**Re:** Variance Request – Roemhildt Holdings LLC

Re: Lots 5, Block 2 South Fill Development Variance Request

**Re:** Site Plan Review – Roemhildt Holdings LLC

Re: Lots 5, Block 2 South Fill Development Site Plan

1) Site 1/16" = 1'-0"

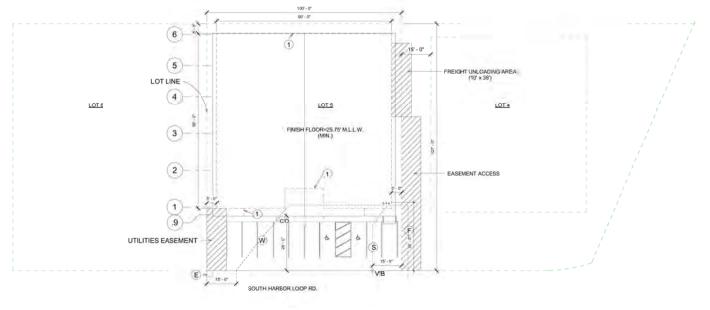
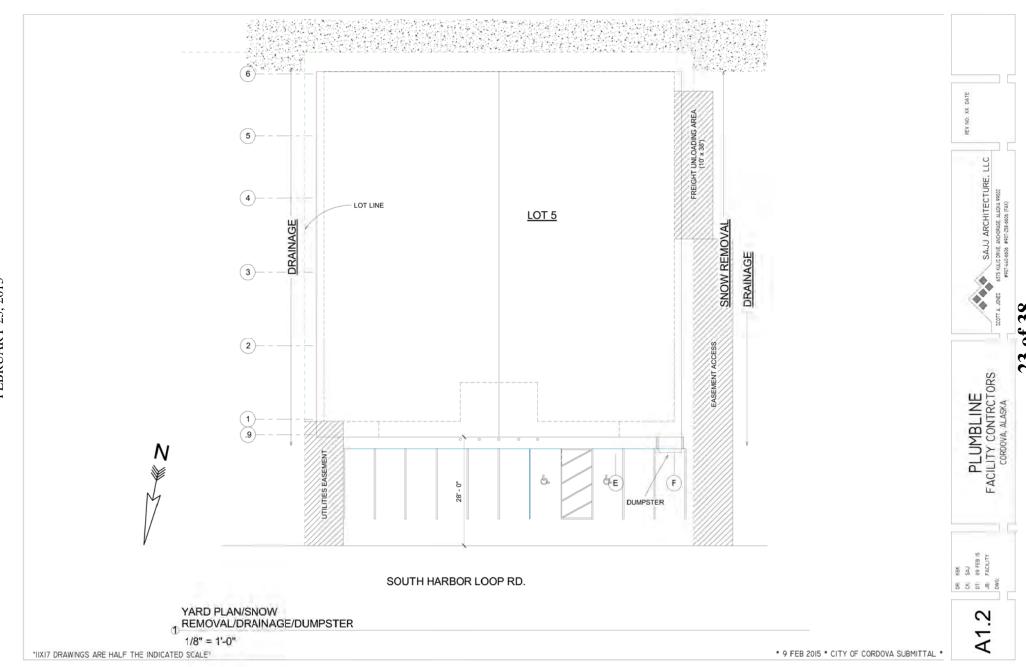
McGann said that he is in favor of new retail buildings in town. He said he does have some problems with the application. Some of the required information for a site plan review has not been provided: the north arrow, the elevations are incorrectly labeled, there are no abutting properties shown, and there are no driveways shown. These are minor issues that could be corrected with a drawing revision. His biggest problem is with 18.48 and off-street parking and how the square footage is being calculated. The Code says one parking spot for each 600 square feet of gross floor space. "Floor area" is defined in 18.08 as the total of each floor of the building within the surrounding outer walls. In the application, Roemhildt Holdings says the area is 8,640 square feet. If you take out the numbers from the architect's drawings the number is 11,654 square feet, which would require 20 parking spaces. The square footage based on the definition is about 13,000 square feet. The IBC definition for floor space would include even more.

**Pegau** said that he also had concerns with the off-street parking. He said there is also supposed to be a space for off-street loading and unloading. When you're looking at this size of a retail building without any ability to bring in a trailer or large vehicle for loading and unloading it doesn't seem realistic. He is also concerned about buildings being so close to the edge of the lot and what that means for snow coming off the roof.

S. Greenwood clarified that the commission wanted the correct dimensions, the north arrow, abutting properties, easements, drawing elevations were mislabeled, a way to generate square footage, and a way to deal with offloading and parking spaces. Baenen asked if the issues were going to be addressed by a variance request. Pegau said that would be the proper way to do it. Pegau said that he would like to know if there is the intent to use snow arrestors on the roof.

- 1. Correct dimensions match building drawing and application numbers. The building area as defined by CMC 18.08.120 is "the total of all areas taken on a horizontal plane at the main grade level of the principle building and all accessory buildings, exclusive of steps." We interpret that the 4' second floor overhang in the front of the building and the covered entry area would be included. Building area totals 8348 square feet. The floor area as defined by CMC 18.08.260 is "the total area of each floor of a building within the surrounding outer walls but excluding vent shafts and courts." We interpret that this area total would not include wall thickness, which is 12" in all instances (8" columns / wall girts with 4" insulated panels added to exterior). Floor area totals 11,836 square feet. Please consider these numbers as sufficient for decision making on this site plan review. I do not know which to put on the application.

- 2. North arrows on all drawings. Attached.
- 3. Show utility easement on drawings. Attached.
- 4. Fix labels on the elevation drawings. Attached.
- 5. Snow arrest on roof? -not a requirement but was asked. We will not be using snow jacks.

- 6. Provide drawings that show the adjacent lots and buildings –this will be very important to help with parking and loading zone. Attached.
